New Fire Station # 10
St. Tammany Fire Protection
2745 Lakeshore Vista Blvd.
Slidell, LA.

Sheet Title: Landscape Planting Plan

LS-1

Flre Station 10 (revised mark up& summaryLA comments 1.27.2026).pdf Markup Summary

LANDSCAPE PLANTING PLAN

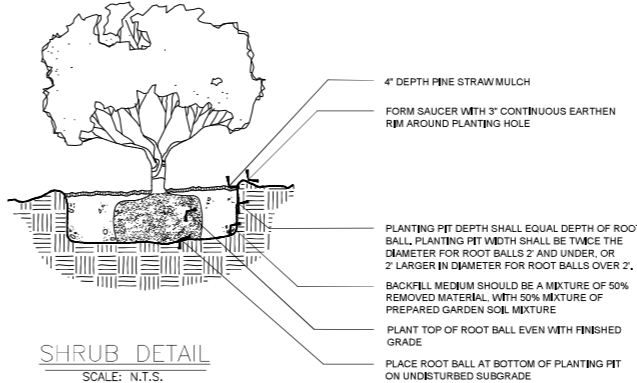
Provide 6" curb on all parking islands per UDC Exhibit 600-3-12 typical.

OK to eliminate island in this location per Ross Limer. Suggest bollard for safety.

Parking is not allowed in buffer unless per section 600-3-14 (f) Flexibility in street buffers. This does not meet the requirements. Revise plan or apply for BOA variance

Suggest moving these spaces to existing row on left side of bld as shown and connecting with sidewalk to entry.

Add note to plan: Variance for driveway width was approved via Board of Adjustment under case # 2025-4500-BOA

Civil plans show swales on 3 sides in the landscape buffer. Landscape buffer must be provided outside of any servitudes or drainage easements. Move buffer inward to provide required planting area as needed or relocate swales outside of buffers.

Indicate zoning of site on plan. LV-3 as Lakeshore Estates PUD.

Landscape Plan shall identify pervious/impervious areas to comply with Sec 600-3.4 (D)(1). Provide min. 30% pervious area.

Dimension all buffers, driveways, drive aisles, islands and typical parking spaces.

Parking islands must meet requirements of Unified Development Code Chapter 600-5.1 Parking Requirements. Provide 9x18' islands with Class 'A' tree and living ground cover and 6" curb at the end of each row of parking. Island required at the end of each row and max 12 spaces between islands.

Indicate the building square footage and use of all structures typical.

Per Sec 600-3-17, All storage areas containing 3 or more refuse, garbage, or rubbish containers or 1 or more dumpsters shall be screened on all sides with min. 7' high opaque fence constructed of wood or masonry. All properties which provide prepared foods, and all office and warehouse uses must provide a dumpster and meet the requisite screening requirements.

Coordinate utilities, civil and landscape package to avoid conflicts with existing and proposed trees per code. Typical. Specifically, review drainage and grading to ensure no cut or fill in buffers or below drip line of protected trees.

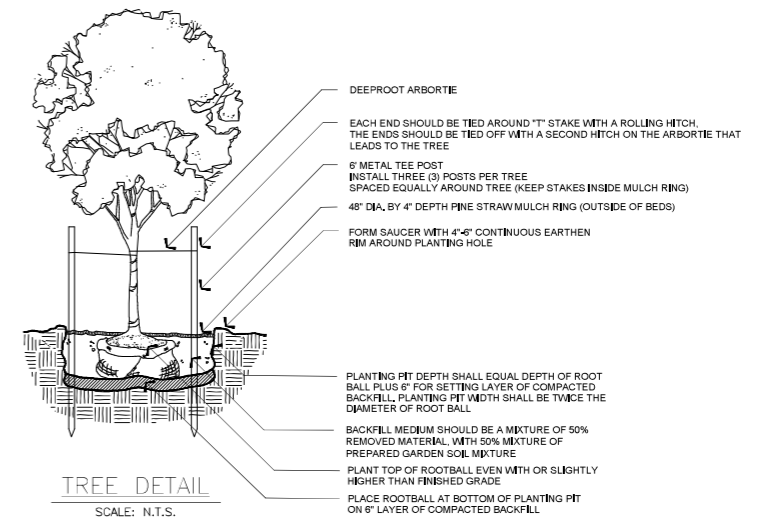
Add Note to plan that surrounding property is zoned LV-3 per teh Lakeshore Estates PUD. Proposed future use will be public or commercial use such as soccer fields.
